Planning Commission Tentative Agenda

Description: 7 Brew – Site Plan & Building Permit Authorization, Conditional Use Permit, and Variance for Lot 1, Block 1, McDonalds at Orchard Place	
Staff Contact: Carter Hayes, Planner	Department / Division: Community Development

TO: Carter Hayes, Planner

A2.2
EXTERIOR ELEVATIONS

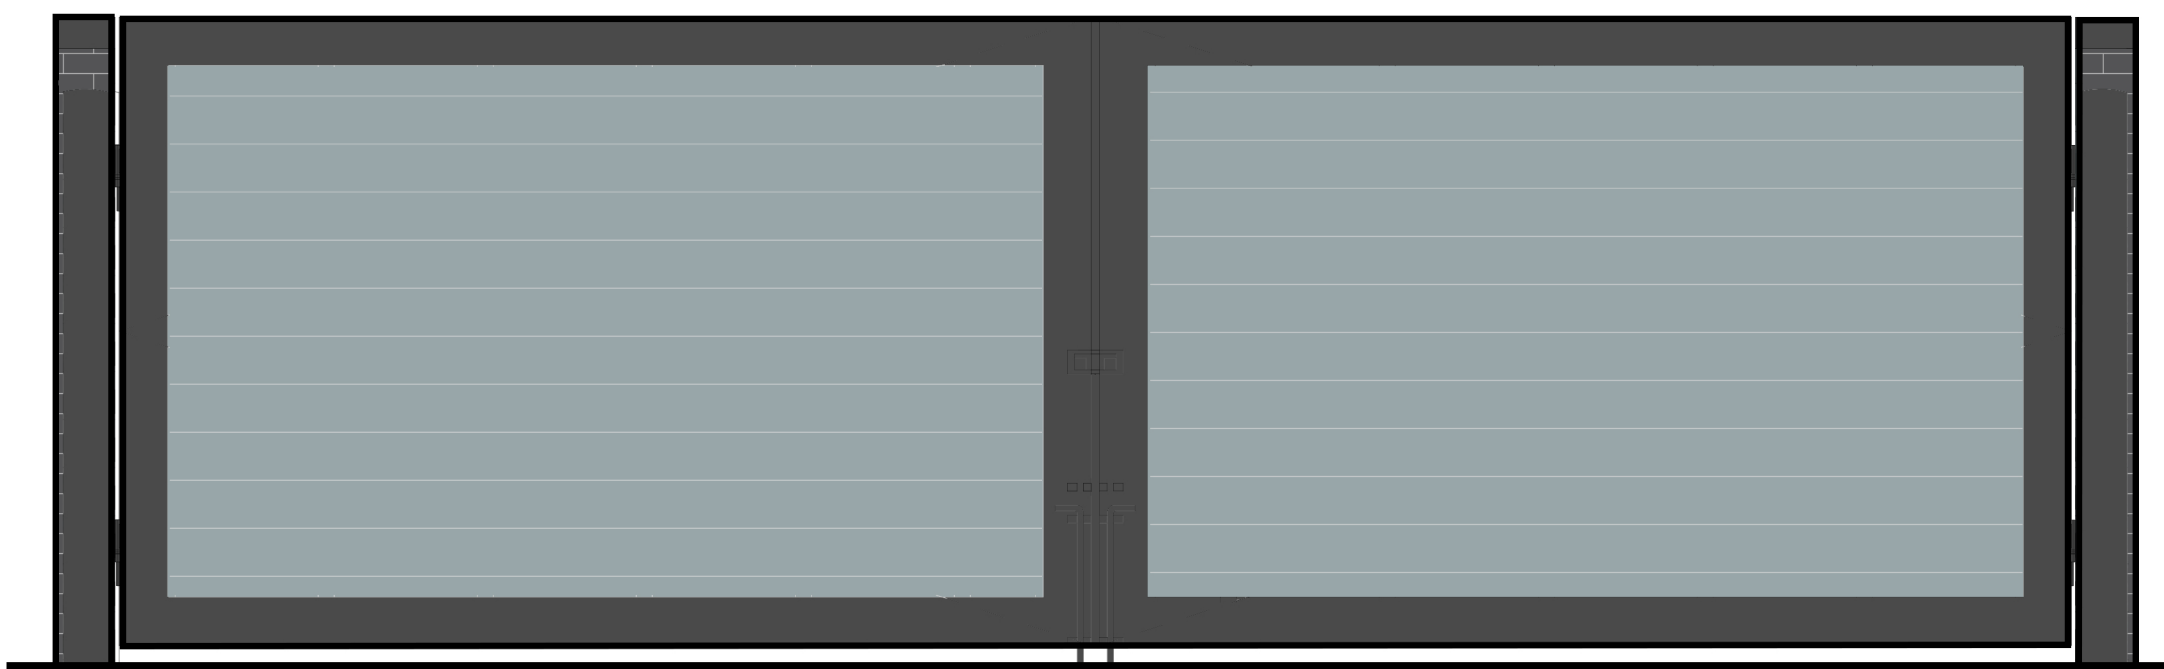
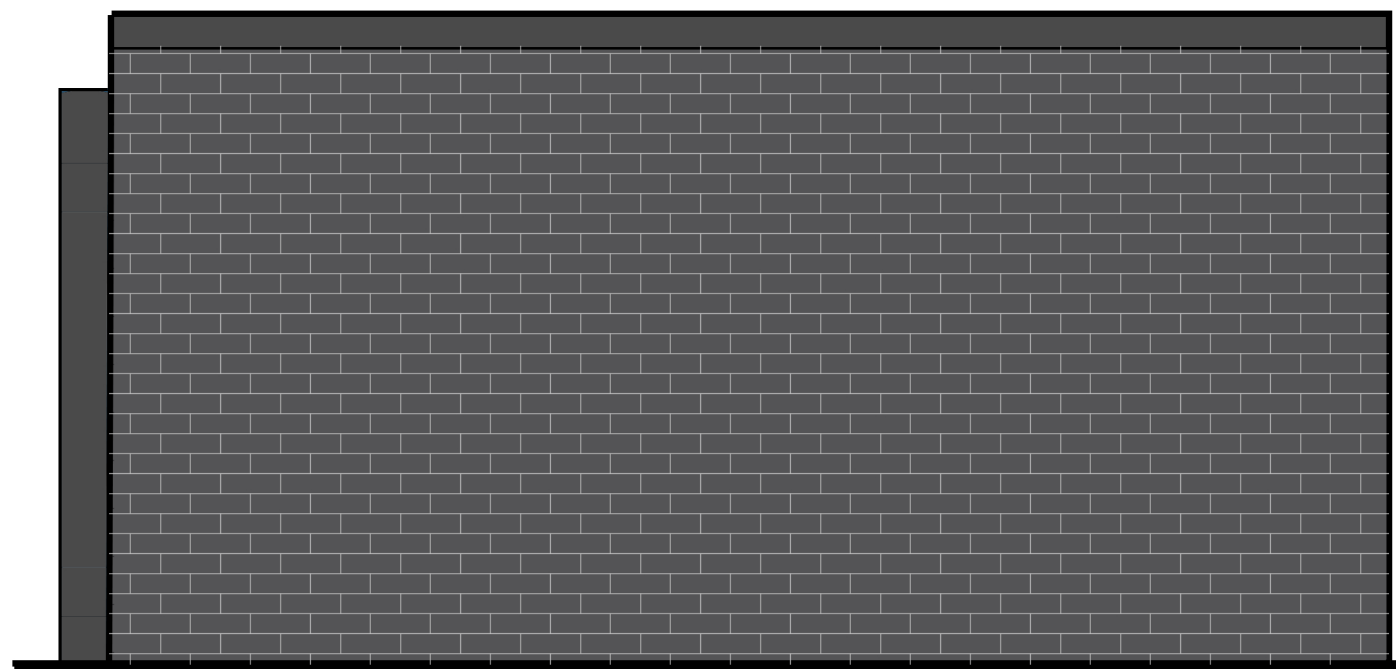
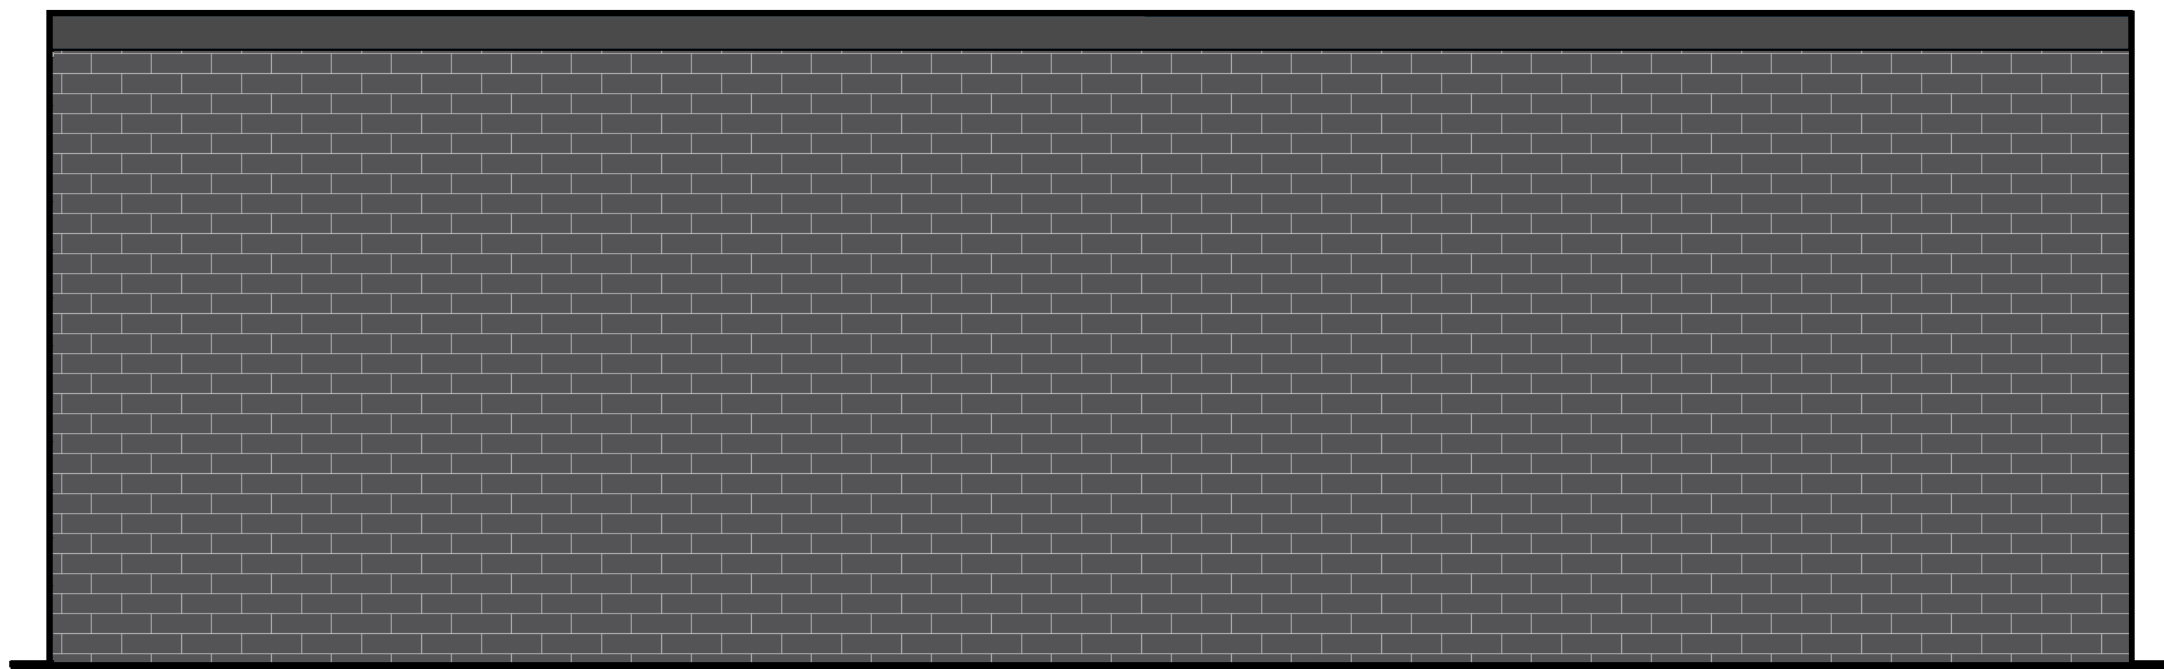
- Folding access ladders are not an approved method for accessing mechanical equipment.
- Plan sheet A2.2 states to refer to A4.1 for energy compliance information. That sheet is not included. Energy compliance must meet the 2024 Minnesota State Commercial Energy Code.
